Subject: Braidwood Nuclear Power Station Units 1 and 2  
NRC Docket Numbers: 50-456 and 50-457

Byron Nuclear Power Station Units 1 and 2  
NRC Docket Numbers: 50-454 and 50-455

Supplemental Information Pertaining to the Technical Specification  
Amendment for "Water Level-Storage Pool" and "Criticality Analysis of  
Byron and Braidwood Station Fuel Storage Racks"

ATTACHMENT  
SUPPLEMENTAL INFORMATION  
PERTAINING TO THE TECHNICAL SPECIFICATION AMENDMENT FOR  
"WATER LEVEL-STORAGE POOL" AND  
"CRITICALITY ANALYSIS OF BYRON AND BRAIDWOOD STATION  
FUEL STORAGE RACKS"

Figure 1

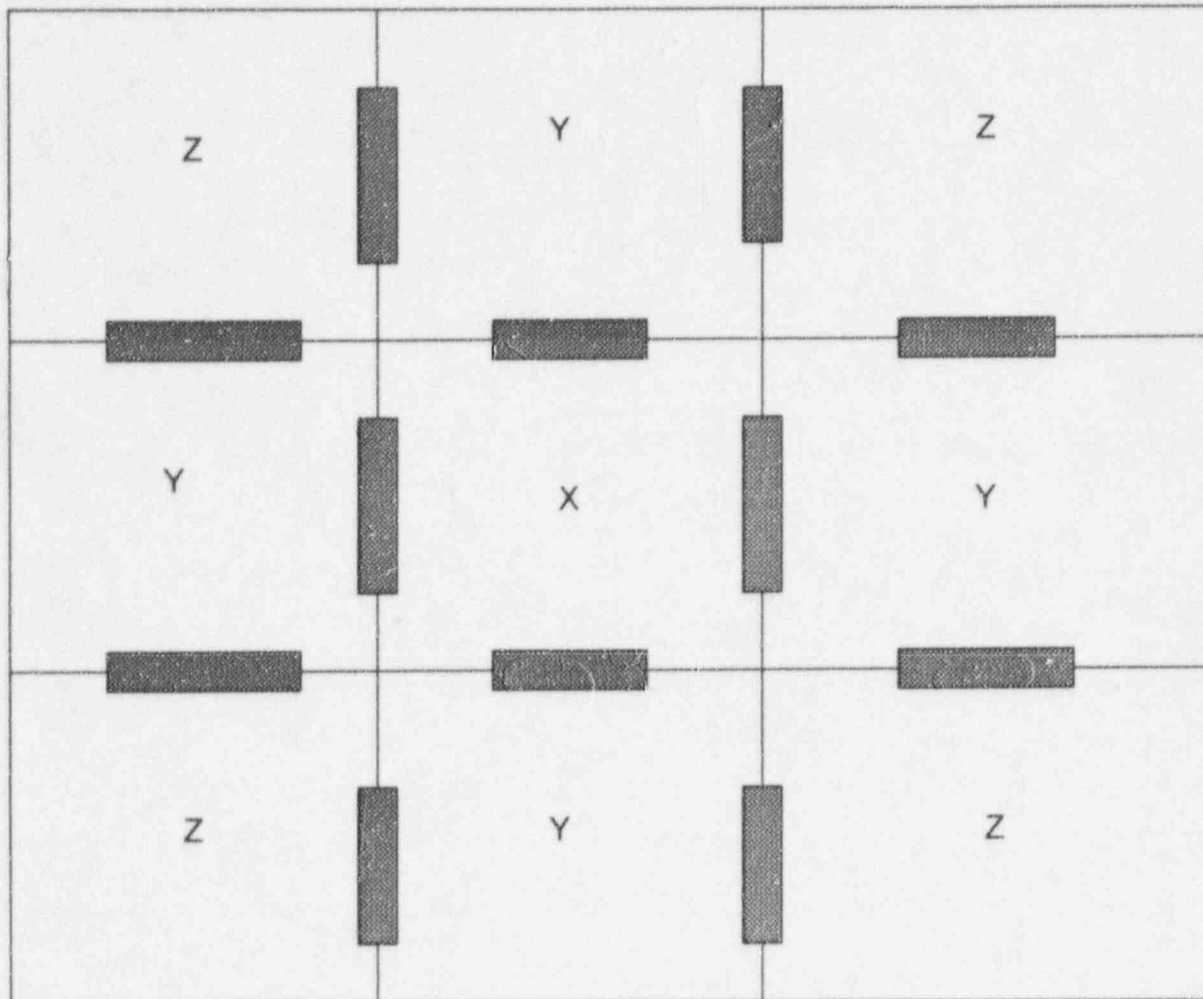
The Byron and Braidwood Region 1 Fuel Storage Racks initial design specifications included Boraflex and no Boral. Due to ComEd's concerns regarding Boraflex degradation, Boral panels were placed in the flux traps during initial fabrication. The Boral panels were inserted into the flux traps that exist between each cell within a rack. Figure 1 shows configuration of the Boral panels within a sample Region 1 rack. Each

interior cell has a Boral panel on all four faces (cells labeled 'X'). The peripheral cells do not have Boral panels on their exterior walls. Therefore, the corner cells have two Boral panels on their interior faces (cells labeled 'Z') and the other peripheral cells have three Boral panels on their interior faces (cells labeled 'Y').

The criticality analysis to support the Technical Specification revision, CAC-96-248 "Byron and Braidwood Spent Fuel Rack Criticality Analysis with Credit for Soluble Boron" modeled all the Region 1 cells with Boral panels on all four faces. This analysis did not specifically model the peripheral Region 1 cells that do not have Boral panels on their exterior faces. Therefore, this criticality analysis did not adequately model the actual Boral configuration of the Region 1 fuel storage racks.

To adequately model the actual Boral configurations, two additional cell configurations have been analyzed in the supplemental analyses. These include: 1) a cell with Boral on three faces (cell Y in Figure 1), and 2) a cell with Boral on 2 faces representing the corner cell location (cell Z in Figure 1).
